**PLEASANT PRAIRIE PLAN COMMISSION MEETING
VILLAGE HALL AUDITORIUM
9915 39th AVENUE
PLEASANT PRAIRIE, WISCONSIN
6:00 P.M.
MARCH 23, 2015**

- A. **PUBLIC HEARING AND CONSIDERATION OF PLAN COMMISSION RESOLUTION #15-06 FOR THE FOLLOWING COMPREHENSIVE PLAN AMENDMENTS** for the request of Leah Berlin on behalf of Kwik Trip, Inc. related to the proposed development of a Kwik Trip to be located at the southwest corner of STH 50 and CTH H: 1) to amend the Village 2035 Land Use Plan Map 9.9 to remove the urban reserve land use designation from the property identified as Tax Parcel Number 91-4-122-081-0010 to ensure that both the Zoning Map and the Comprehensive Land Use Plan are consistent; and 2) to update Appendix 10-3 of the Village of Pleasant Prairie Wisconsin, 2035 Comprehensive Plan to reflect the above noted changes to the 2035 Land Use Plan Map 9.9.

- D. **PUBLIC HEARING AND CONSIDERATION OF A CONDITIONAL USE PERMIT INCLUDING SITE AND OPERATION PLANS AND DIGITAL SECURITY IMAGING SYSTEM AGREEMENT AND ACCESS EASEMENT** for the request of Leah Berlin on behalf of Kwik Trip, Inc. related to the proposed development of a Kwik Trip to be located at the southwest corner of STH 50 and CT

DRAWN BY: JSK/RWI
 SCALE: 1" = 30"
 JSD PROJ. NO.: 14-6612A
 DATE: 02-15-2015
 SHEET: 9 OF 22 SP5.1

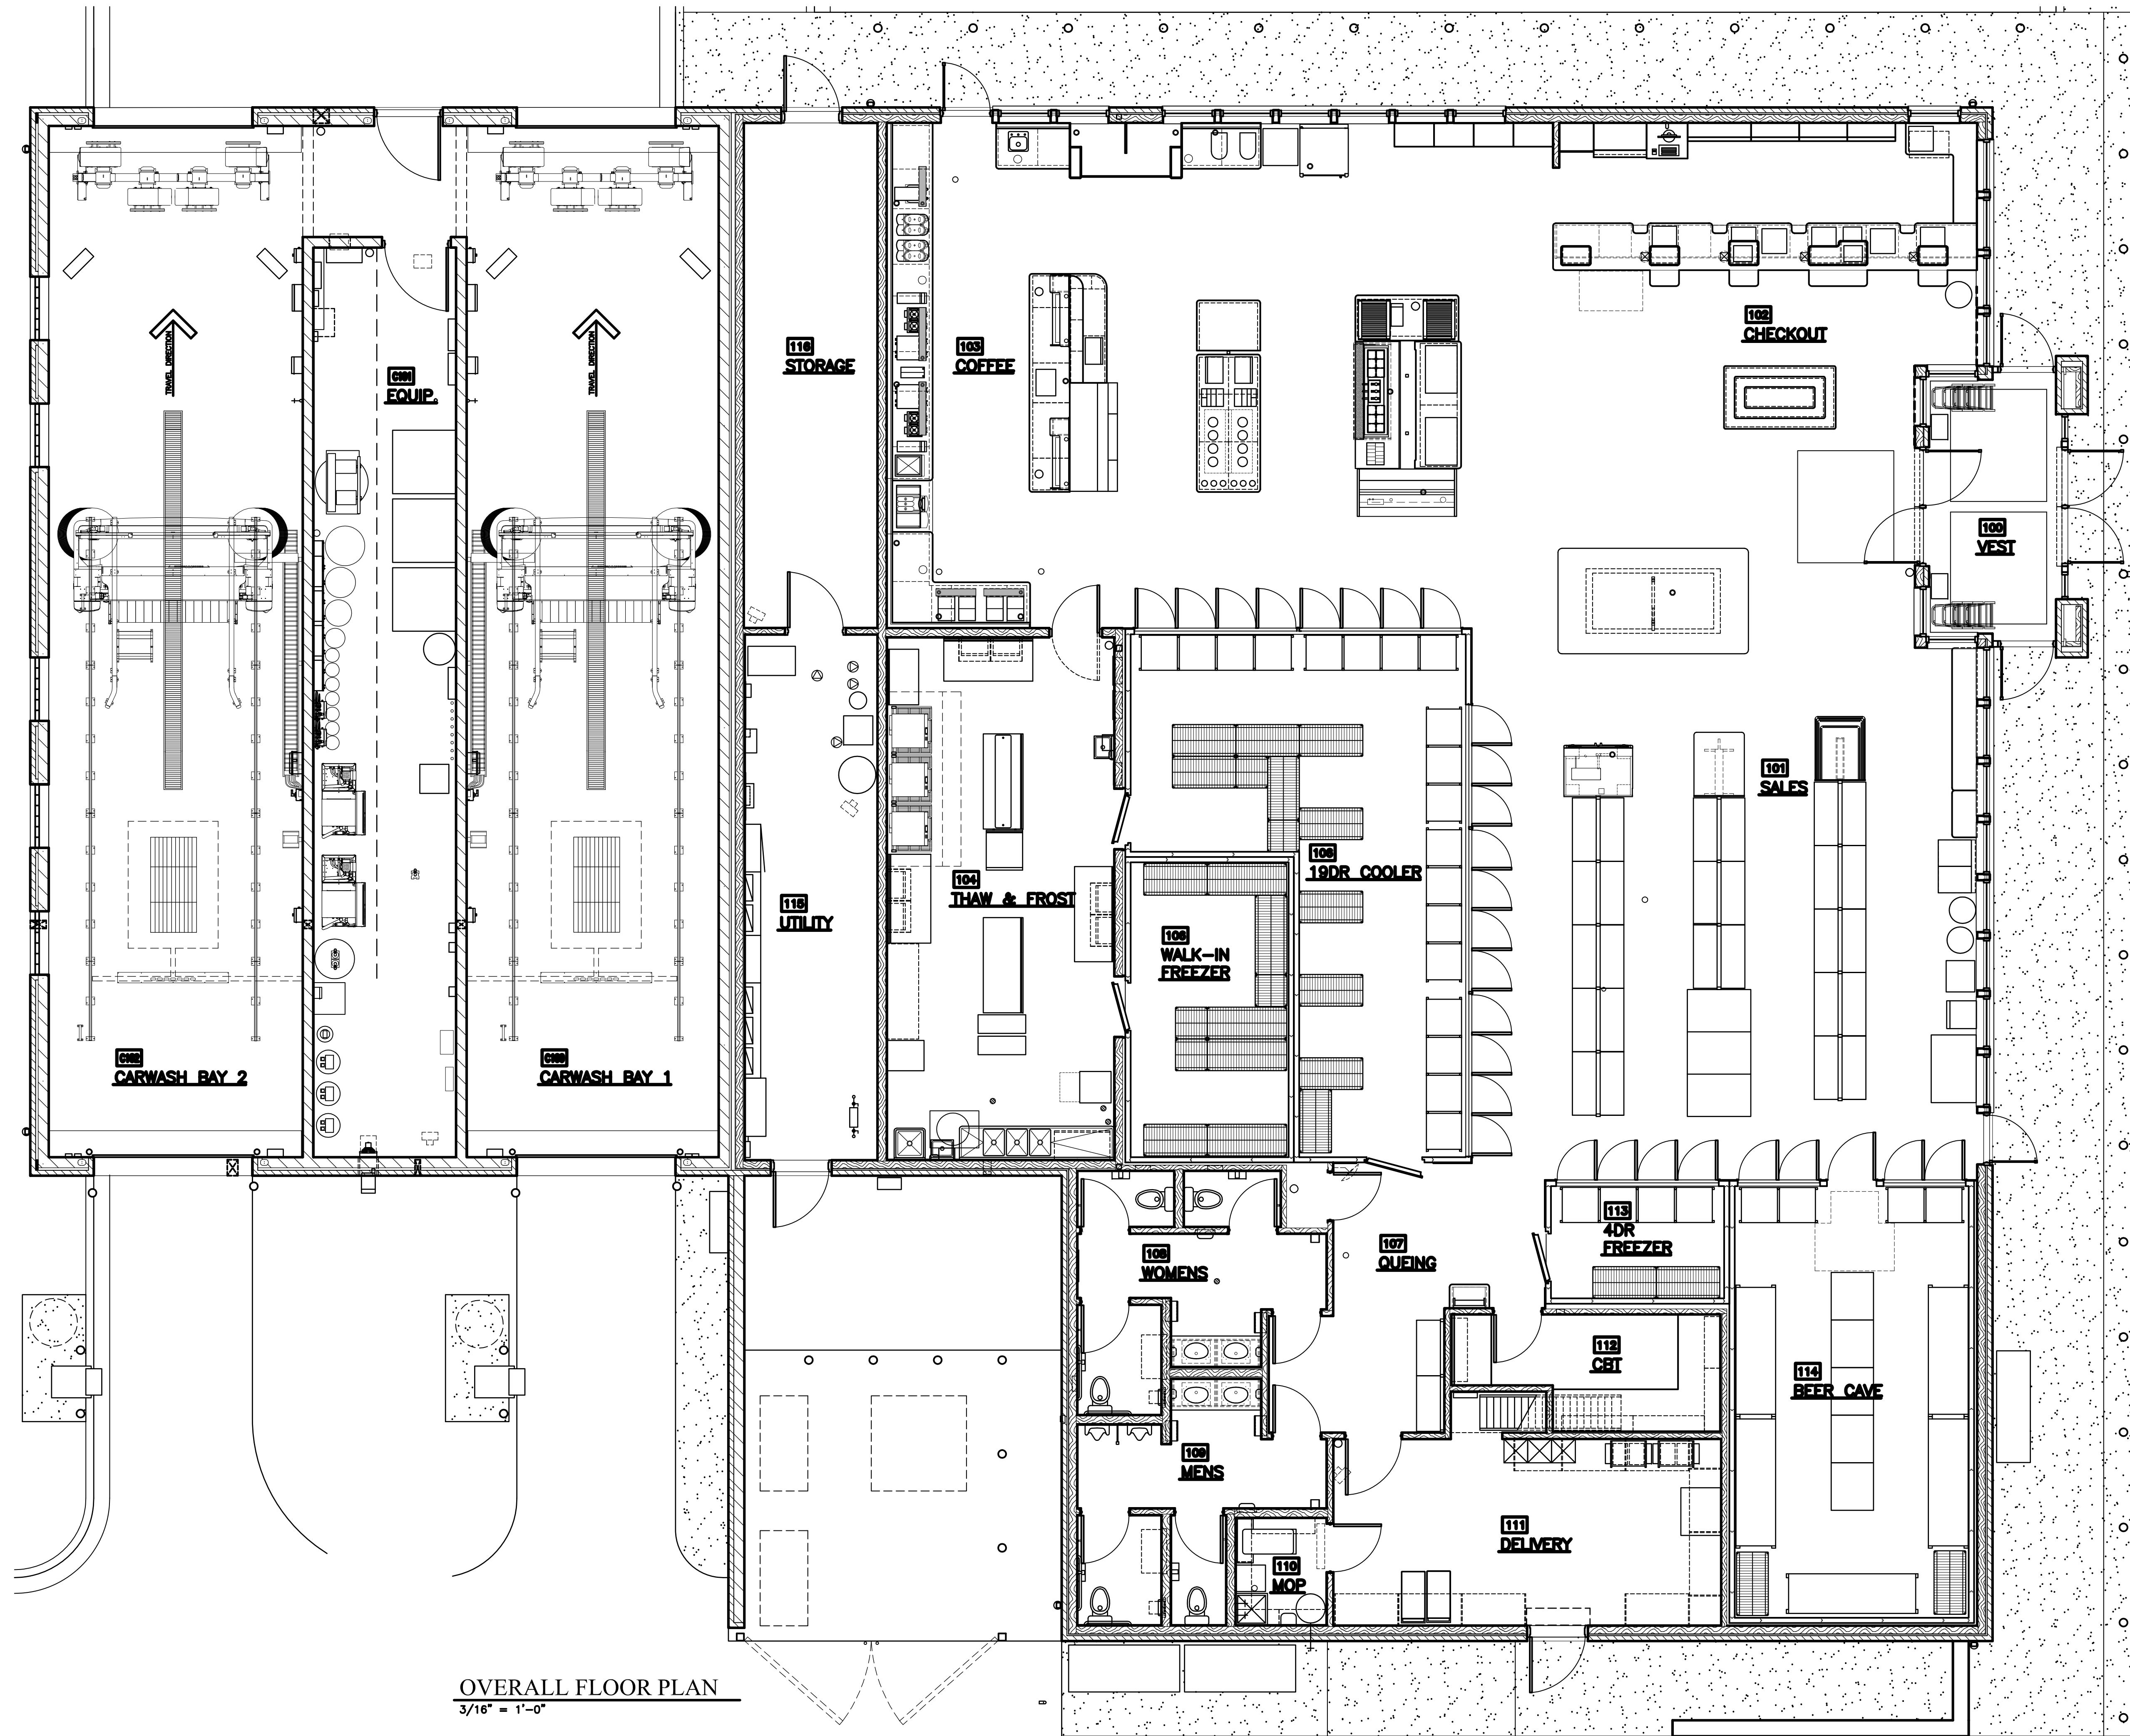
- ix. On the *Notes and Details (Sheet SP5.0)* add a typical section for public sidewalk.
- x. On the *Notes and Details (Sheet SP5.1)* the following shall be changed:

6. Add a Standard Sampling Manhole Detail – Village will provide.

7. Add a Palmer-Bowles Flume Detail – Village will provide.

DIRECTIONAL SIGN #12

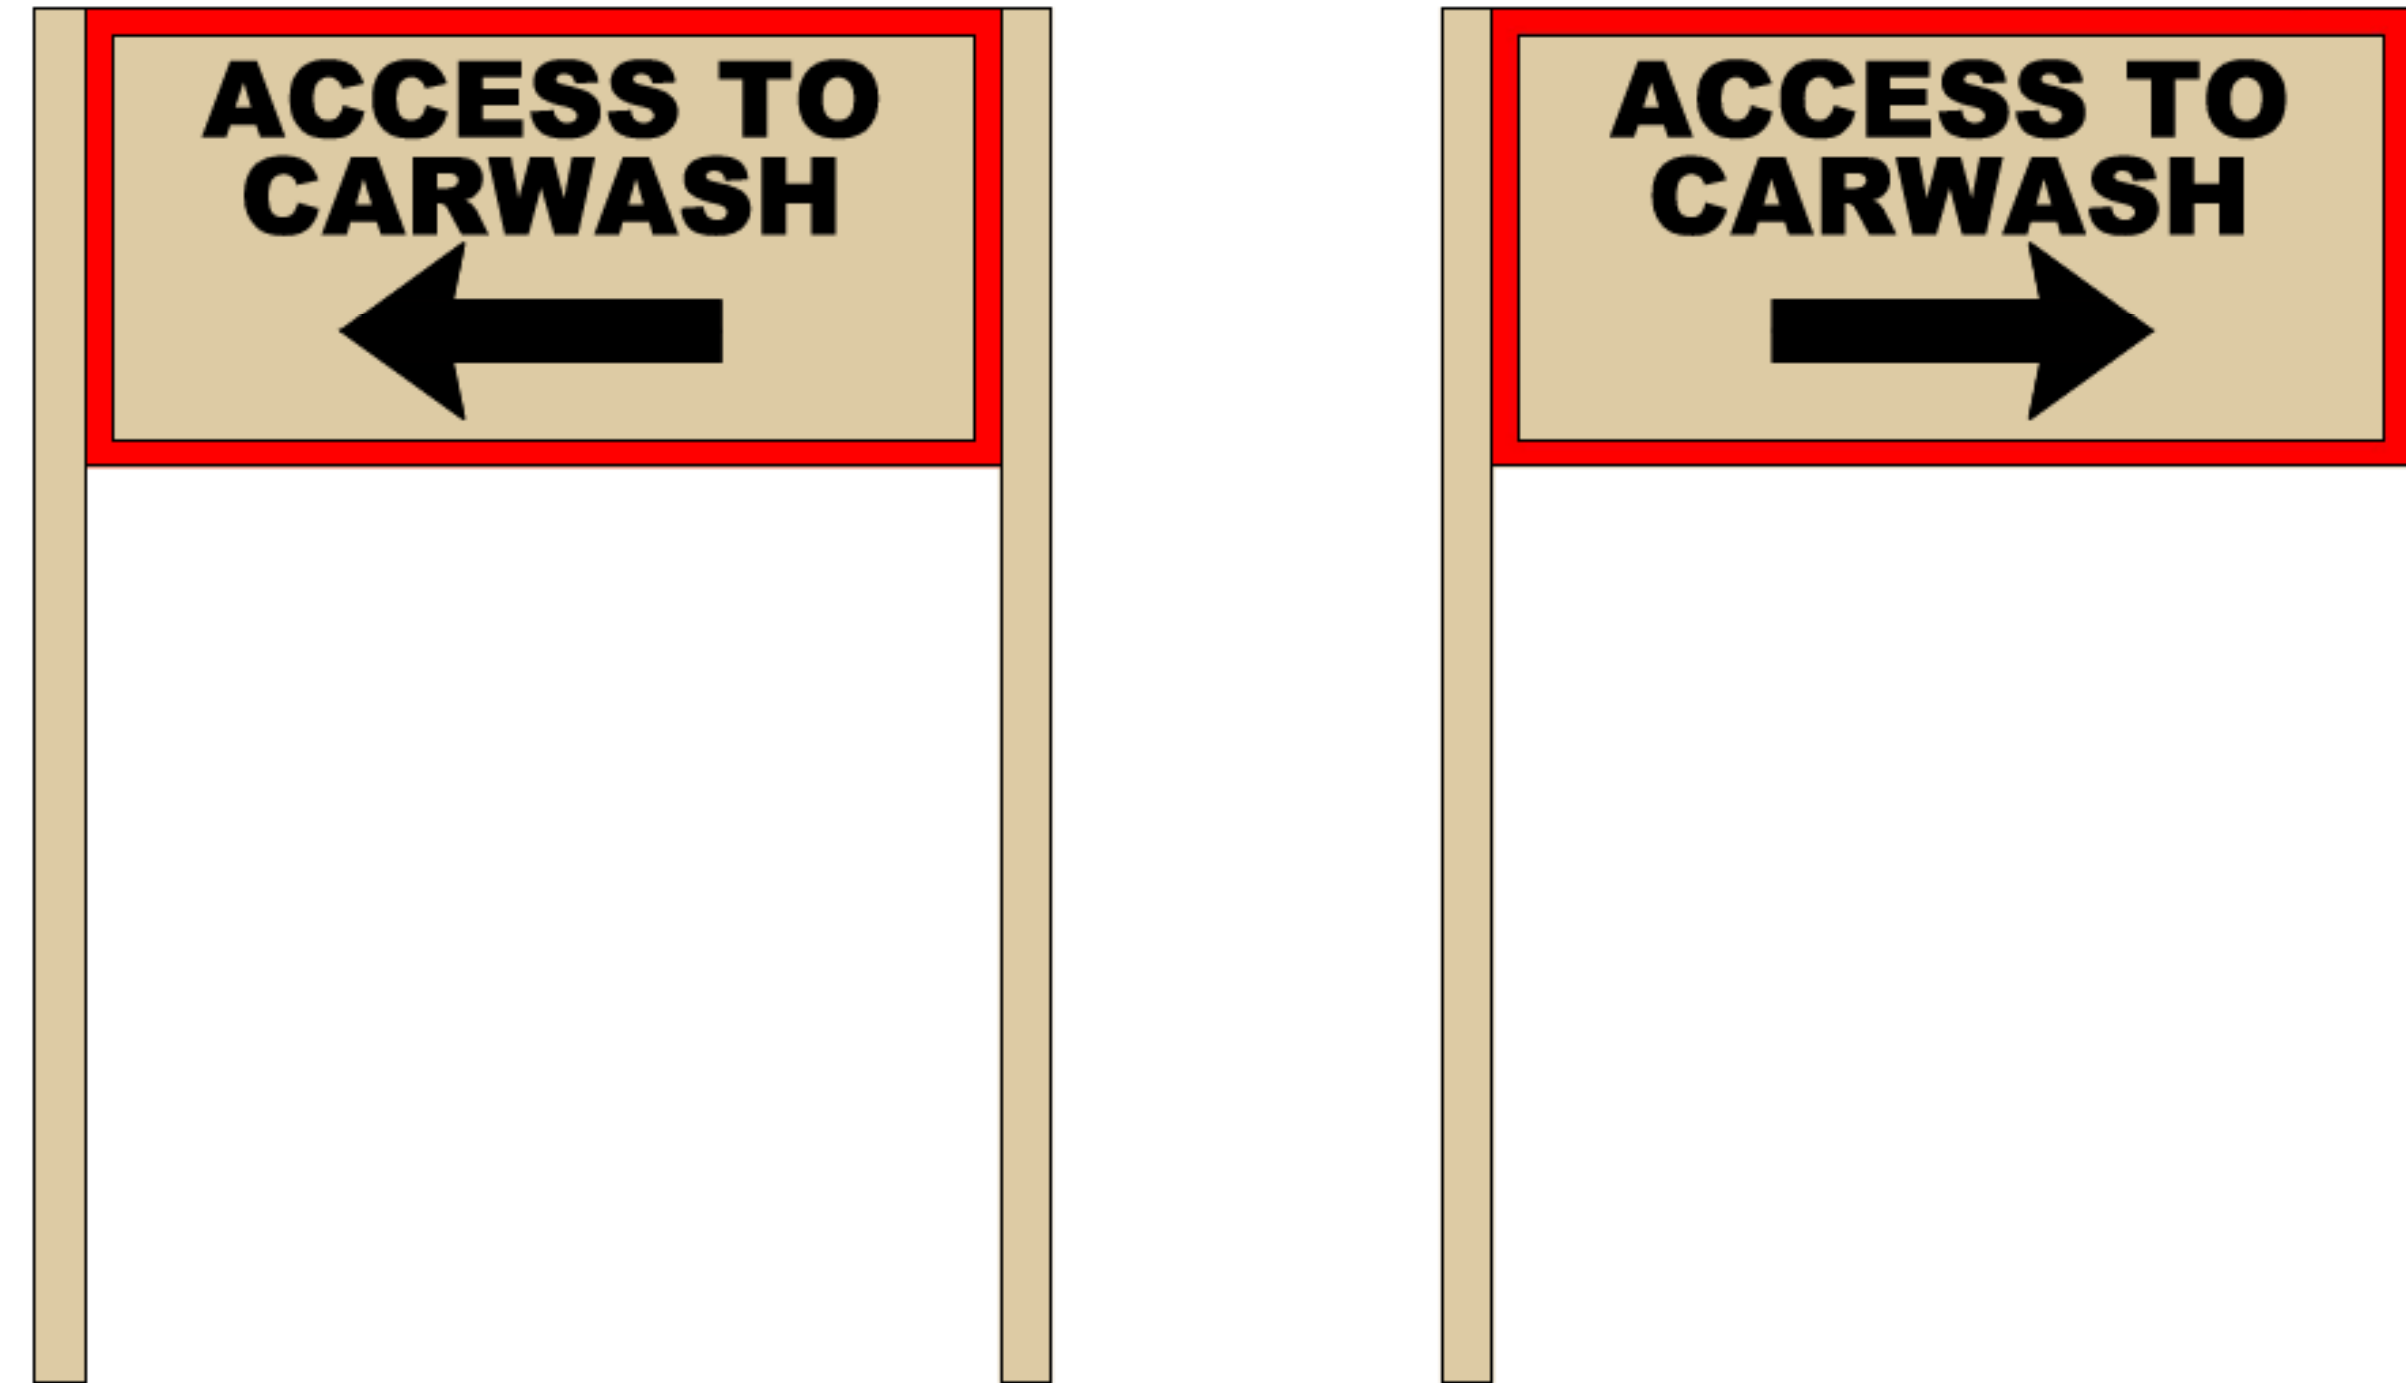
- r. Modify Plan Sheet 19: the freestanding directional signage maximum height is 4 feet from grade.
- s. Modify Plan Sheet 20:
 - i. The maximum height of a primary monument sign adjacent to STH 50 shall be consistent with all other single users on STH 50 in Prairie Ridge which is a maximum of 10 feet – reduce sign height with a maximum area of 90 square feet. The maximum height for the second primary monument sign is 6 feet with a maximum area of 60 square feet (See PUD Amendment).

PHOTOMETRIC SITE PLAN
SCALE: 1" = 30'-0"

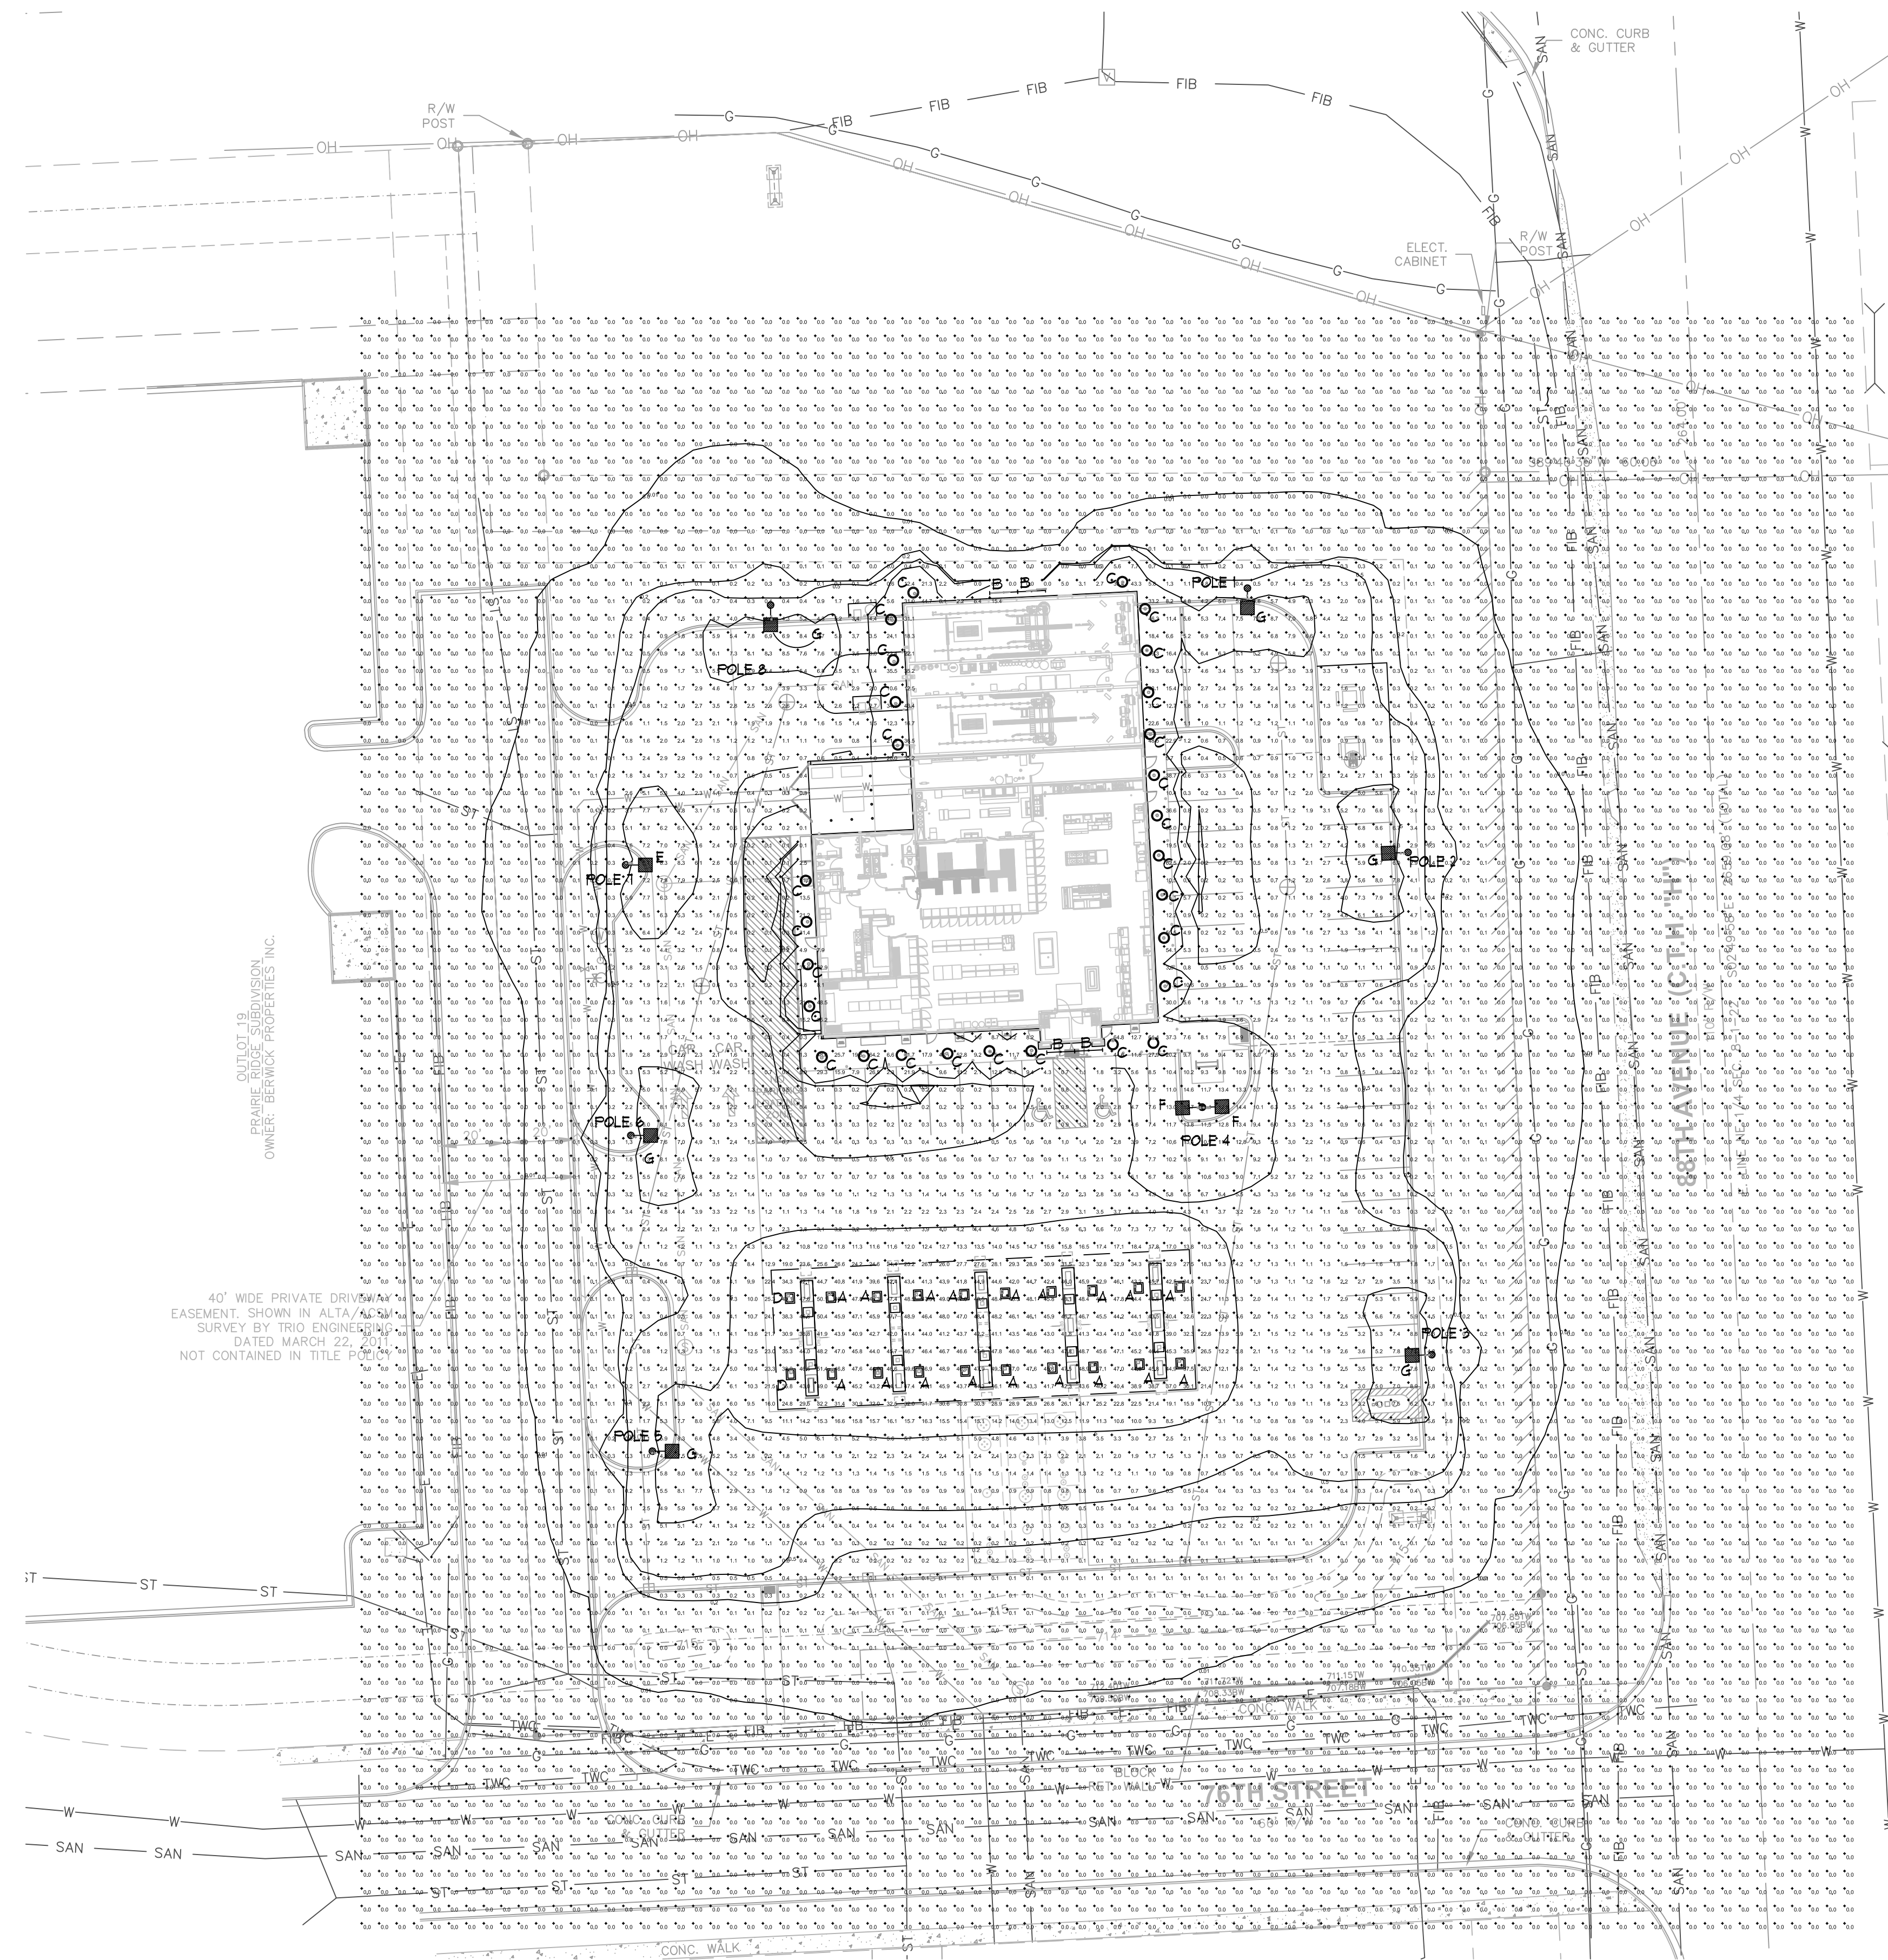
- iii. Note the brick used on the signage shall be identical to the building brick.
 - t. Modify Plan Sheet 22:
 - i. The light poles in the lot shall be black to match the site colors not white.
